DP83846 to DP83848C/I/YB PHYTER System Rollover Document

National Semiconductor
Application Note 1499
Suganya Sankaran
October 2006

Purpose

FIGURE 1. Special Connection in DP83848C/I/YB

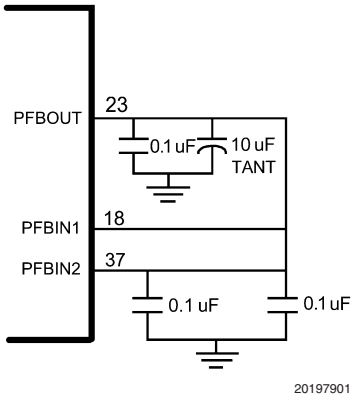
Parallel capacitors (10uF Tantalum capacitor and 0.1uF) should be placed close to pin 23 (PFBOUT, the output of the regulator) in DP83848C/I/YB. In DP83848C/I/YB, Pin 18 (PFBIN1) and 37 (PFBIN2) should be externally connected to pin 23 as shown in *Figure 1*. A small 0.1uF capacitor should be placed close to pin 18 and pin 37. DP83846 does not require a similar connection.

FIGURE 2. DP83848C/I/YB PMD Connections (Termination & Biasing)

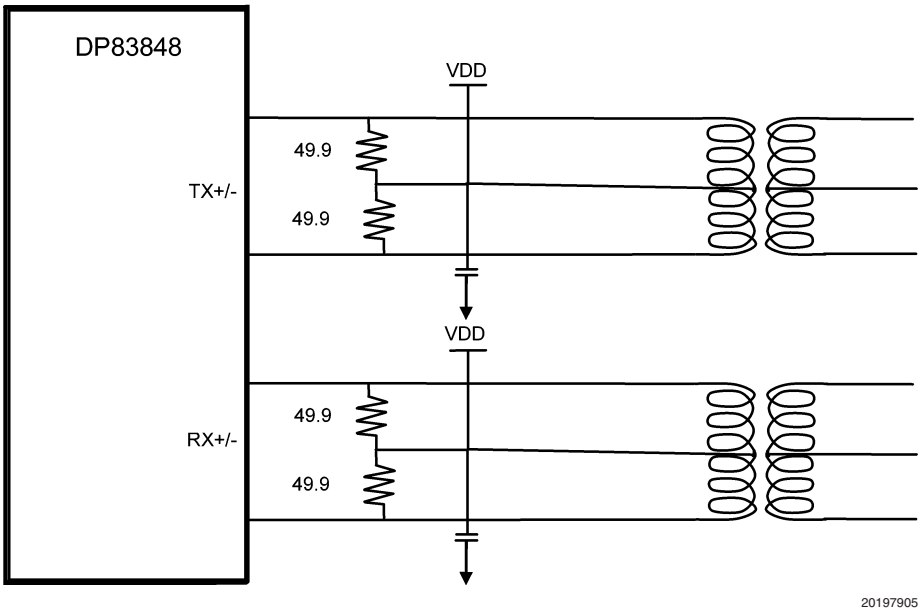
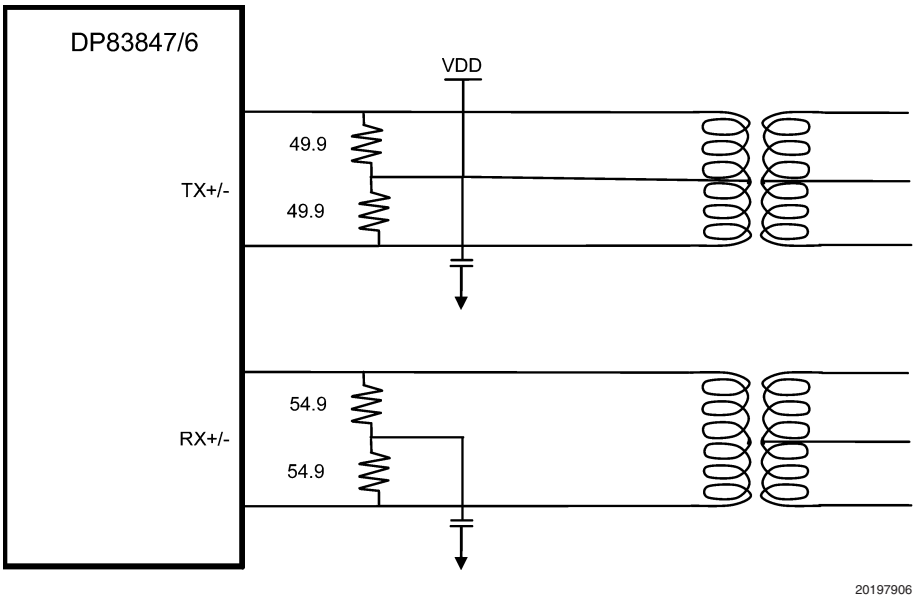
Termination of the PMD receive pair (TPRD+/-) on previous Physical Layer devices consisted of a pair of 54.9 Ohms, AC biased to GND. This value, when seen in parallel with the internal receiver circuitry, provided an equivalent of 100 Ohms impedance. In DP83848C/I/YB the internal receiver circuitry has changed and now requires a pair of 49.9 Ohm resistors, biased to VDD of the device.

This matching of the termination resistors and common biasing between the receiver and transmitter of the DP83848C/I/YB allows the addition of the Auto-MDIX feature to the device.

DP83848C/I/YB	DP83846
TX Termination	49.9 Ohms	49.9 Ohms
TX Bias	3.3V	3.3V
RX Termination	49.9 Ohms	54.9 Ohms
RX Bias	3.3V	AC to GND

Refer to the next set of figures for a graphic explanation of this.

FIGURE 4. RMII Selection on DP83848C/I/YB

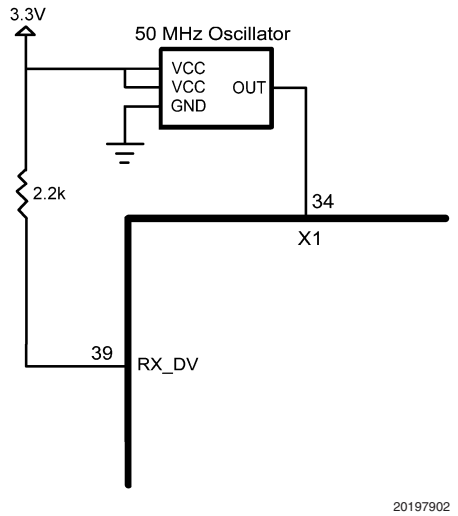
DP83848C/I/YB uses an external 50MHz clock (X1) as reference for both tranmsit and receive in the RMII mode. This is provided by an external oscillator. RX_DV should be pulled high using a 2.2K Ohm resistor to enable RMII mode.

FIGURE 5. Auto_MDIX Operation in DP83848C/I/YB

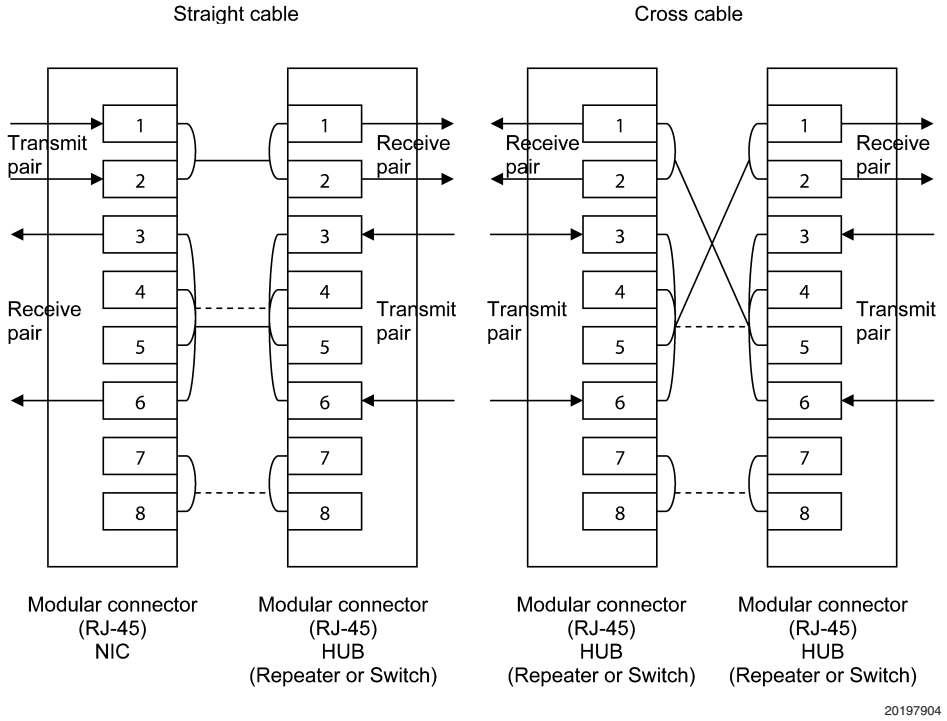
Auto_MDIX removes cabling complications and simplifies end customer applications by allowing either a straight or a cross-over cable to be used without changing the system configuration. Auto_MDIX is enabled by default in the DP83848C/I/YB. In order to disable Auto_MDIX, pin 41 (RX_ER) should be pulled to ground using a 2.2 K Ohm resistor. When enabled, this function utilizes Auto_Negotiation to determine the proper configuration for transmission and reception of data and subsequently selects the appropriate MDI pair for MDI/MDIX operation.
